## 802.1Qbg VDP change proposal

**bg-wang-VDPIDSize-0211**

# Proposed VSI changes

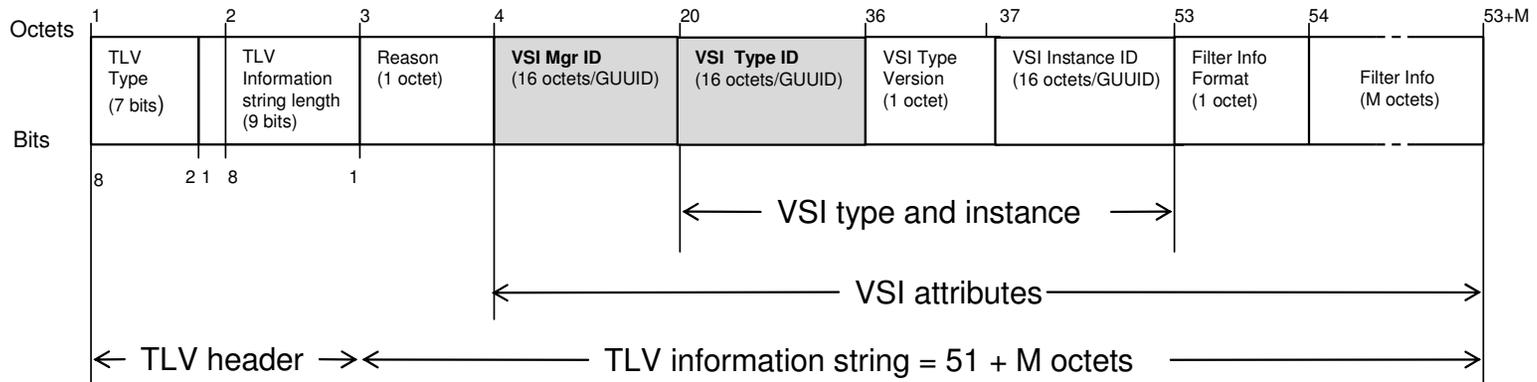
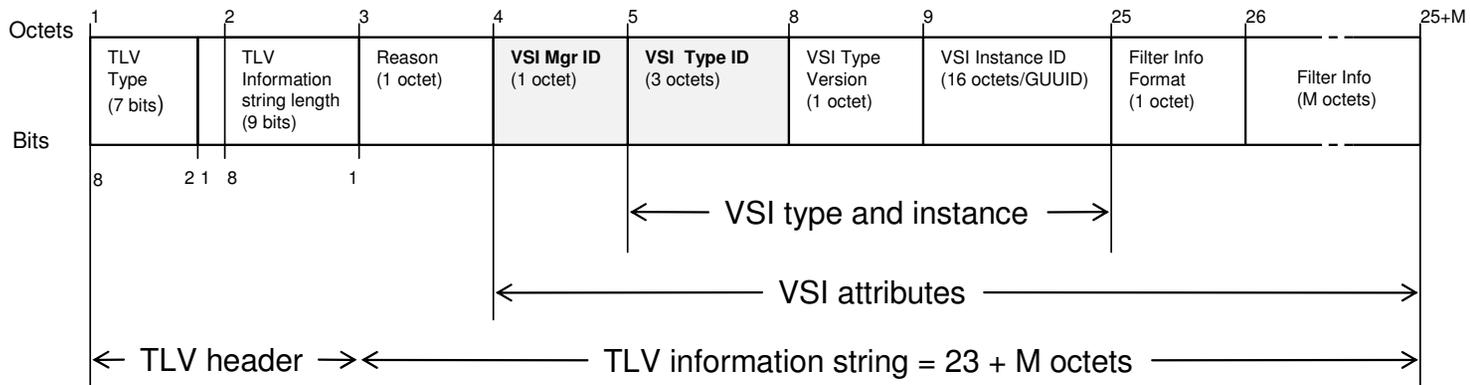
- Proposed changes for some 802.1Qbg VDP TLV fields
  - VSI manager ID field increased from current size of 1 octet to GUUID-sized 16 octets
  - VSI type field increased from current size of 3 octets to GUUID-sized 16 octets
  - Both changes will enable support for multiple independent management planes with a VSI manager

- The VSI manager ID field identifies which VTDB to use for a particular request. The VTDB scopes the rest of the VSI request.
- The current size of 1 octet will allow up to 256 separate VTDBs to be enumerated in a data center. This seems inadequate for large data centers, where many scopes may be desired for access control.
- Making the VSI manager ID a GUID will solve any current and future sizing issues, allowing for many separate VTDBs.
  - A GUID will also allow different management planes to specify their own manager IDs without coordination between the management planes, or fear of collisions.
  - A GUID will also avoid collisions when merging two data centers and associated management planes together.

- The VSI type field along with the VSI type version field and the VSI instance field, identifies which VSI type to use for a particular request.
- The current size of 3 octets will allow up to  $2^{24}$  separate VSI types to be enumerated in a data center. So space is not really a problem here.
- Enumeration of VSI type (and therefore port profile IDs) is currently assumed to be managed by the data center administrator. However, this assumption may be invalid in the face of different management planes.
  - Making the VSI type a GUID will eliminate this assumption, as each management plane can create its own unique identifiers for VSI types based on local factors. VSI types can then be unique across the data center without any coordination needed between management planes.
